Re: BARBER FOODS

We are writing to address review comments made by Associated Design Partners, Inc. (ADP) and S.W. Cole Engineering, Inc. (SWC) regarding our Barber Foods Shoring System Design. Copies of SWC's letter dated 3/10/03 and ADP's letter dated 3/11/03 are included for reference.

Subject: Barber Foods Pretreatment Building
Shoring Plan Review Comments

RE: Barber Foods Wastewater Pre-Treatment Building
Shoring System/Underpinning Design

REVISED RAIL-STUD ANALYSIS : BARBER FOODS

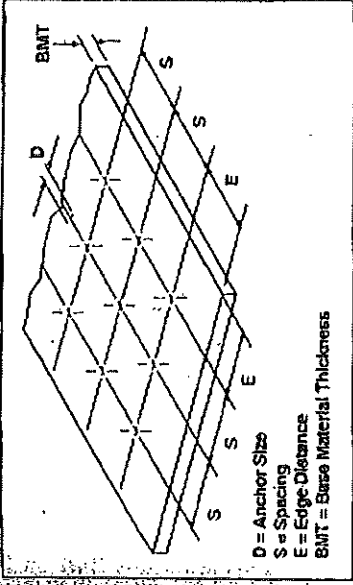
1. The attachment of the "DSI threadbar" at the existing building foundation wall (section D-D) has a calculated factor of safety of 1.88. The minimum factor of safety required is 4.00 +/- 0.33. This factor of safety may require the use of chemical anchors instead of expansion bolts.
2. Detail 4 of the above referenced attachment, does not provide the minimum spacing between bolts in a row, or the minimum spacing between rows of bolts. Bolt spacing should be selected to minimize overlap of the failure cone. The allowable load per bolt should be adjusted accordingly based on the overlap of the failure cone.

- DSI Threadbar does not call for a Factor of Safety of 4.0. Rawl-Studs do. We propose using 8 ea. 7/8" x 8" Rawl-Studs with a minimum embedment depth of 5.75" instead of the previously proposed 6 ea. Rawl-Studs. (See attached calculations)

- Rawl-Stud spacing and failure cone concerns.
 - All installed Rawl-Studs will be spaced at a minimum of 9" between bolts and rows. As the attached design recommendations from Powers Fasteners indicates, a spacing of 8.75" for 7/8" diameter mechanical anchors allows for a load reduction factor of 1.0.

LOAD ON CONNECTION : 38.65 K

$\frac{7}{8}$ " x 8" RAIL-STUD w/ 5.75" (MIN.) EMBEDMENT

ALLOWABLE LOAD PER RAIL-STUD : $\frac{20.4 \text{ K (SIPERM)}}{4} = 5.1 \text{ K}$

8 EA. RAIL-STUDS

ALLOWABLE TOTAL CAPACITY = $8(5.1 \text{ K}) = 40.8 \text{ K}$

$40.8 > 38.65 \rightarrow \text{O.K.}$

* RAIL-STUDS SPACED 9" MIN. BET. BOLTS & ROWS. *

DESIGN STRENGTH OF RAKE

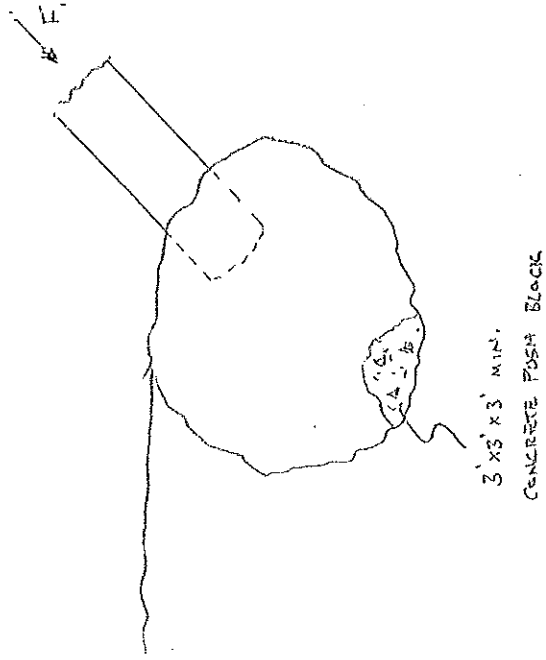
- Push Blocks for rakes appear undersized.
 - As per SWC's recommendation, we will utilize push blocks sized at 7' long x 7' deep x 3' thick.
- Calculation for control of Bottom Heave.

- 1) Push Block for rakes appear undersized.. Recommend Safety Factor of 1.5 (min)
- 2) Calculation for control of Bottom Heave should be included. Sheetpiles should extend to minimum top elevation of 4-feet.
